<p align="center">Solid Minerals Inspection Report Bureau of Land Management Tres Rios Field Office 29211 Hwy 184 Dolores, CO 81323</p>			
Type of Operation	Notice Level 3809 Expl'n	Project Name	Wedding Bell/Radium
Serial Number	COC-80448	Company/Org.	Standard Minerals
Inspection Date	May 13, 2021	Others Present	None
Inspection Time	All Day	Inspected By	James Blair
Report Date	May 19, 2021	Legal	T45N, R18W, Sec 23, 21, 16
Preparer Signature		Supervisor Signature

On Thursday, May 13, 2021 I inspected the Standard Minerals proposed notice-level 3809 exploration plan. The inspection lasted the entire day. Conditions were sunny with scattered clouds, with a temperature around 70°F. The proposed drill sites are accessed using reclaimed drilling roads from previous drilling projects that occurred several years prior, or via overland travel from existing roads. I drove to each site in a clockwise fashion from the 14Y road and then the U29 and Montrose Co. II-13 roads. It would be faster to drive back from the Rimrock and Groundhog blocks by U-29 than by continuing clockwise out and coming up the Fawn Springs Bench road near the Van 4 mine. Photographs and notes were taken at each locatio

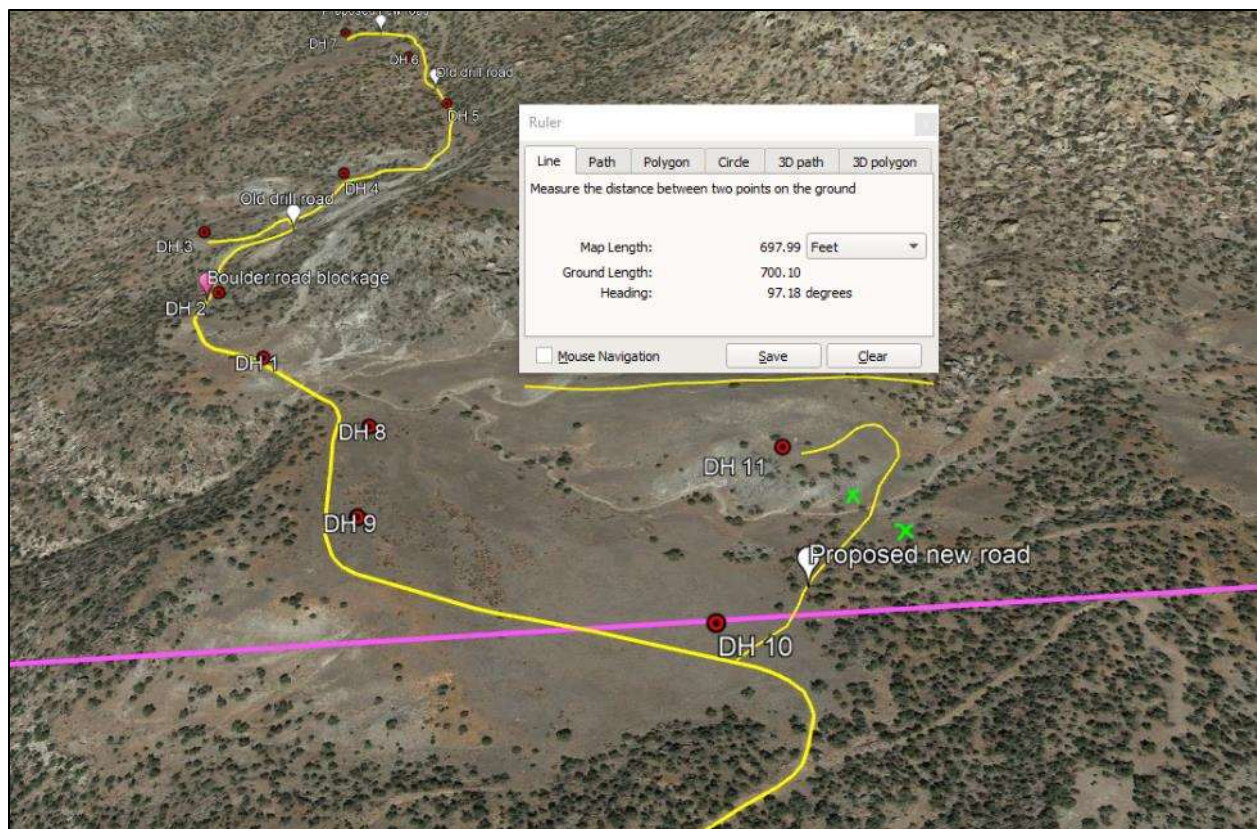
Figure 26: Google Earth screen capture image showing the locations of SDH9, SDH10, and SDH11. Lime colored X's show alternate potential DH11 sites that would cut off over a hundred yards of overland travel. The navigation box in the photo is ~700 feet across, as indicated by the yellow “measure tool” line below the box.

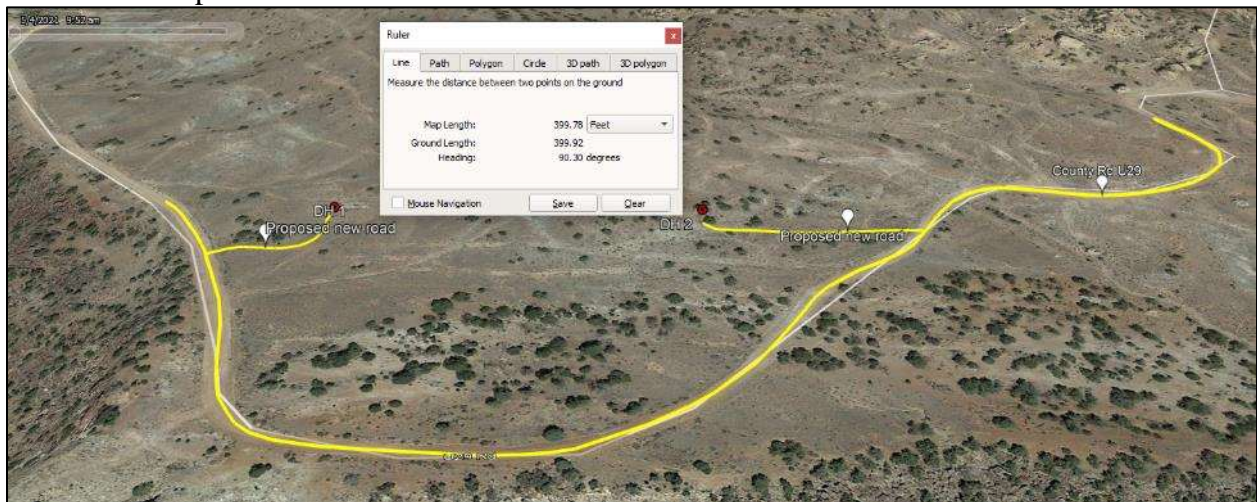
Figure 33: A screen capture of a Google Earth image showing the 2 proposed drill holes for the Groundhog Group. The measurement window is approximately 400 feet and north is up. Both holes look like the access is along very old, reclaimed drill spurs. GDH1 is on the left (west) and GDH2 is on the right (east). During this inspection, I travelled from east to west on the U29 Road. The U29 road is in good shape and does not require any improvements to allow vehicular access even for large vehicles. The proposed access "new road" to GDH2 is actually proposed for an old area that looks like it was once used as overland access to a drill hole at the same location. The access way was only faintly visible, mostly because brush was scattered across the faint 2 track, which had also been revegetated with crested wheat grass and volunteer vegetation. Access to GDH1 appeared to be overland travel and there was no previous disturbance for the "road" however there was an old sump or discovery pit at the proposed GDH1 location. Aerial photography indicates that the site was once accessed via a now-faint overland 2 track. The new location should have brush and rocks scattered across it. Because there is not abundant brush nearby, deadfall from pinon-juniper should be picked up off the ground from other locations adjacent to the U29 and scattered across the travel alignment.

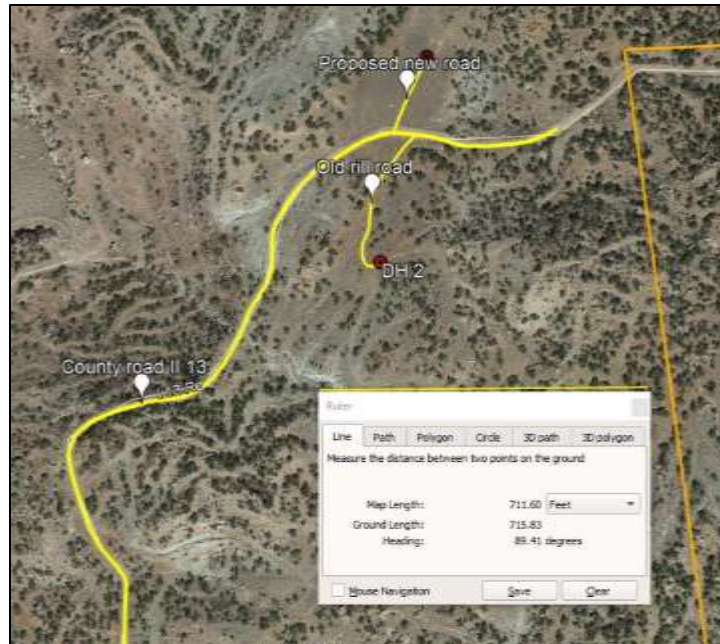
Figure 38: A screen capture of the Rimrock (Radium) Group of proposed drill holes. RDH1 is accessed via “new” overland, though aerial imagery indicates a very faint pre-existing travel route that has since re-vegetated. It is on the north side of the main road, and is not labelled in this photo, but the location is shown by a red dot. The soil is erodible aeolian soil. RDH2 via a pre-existing spur road. The “Ruler” box in the image is ~700 feet across. North is up in the image.
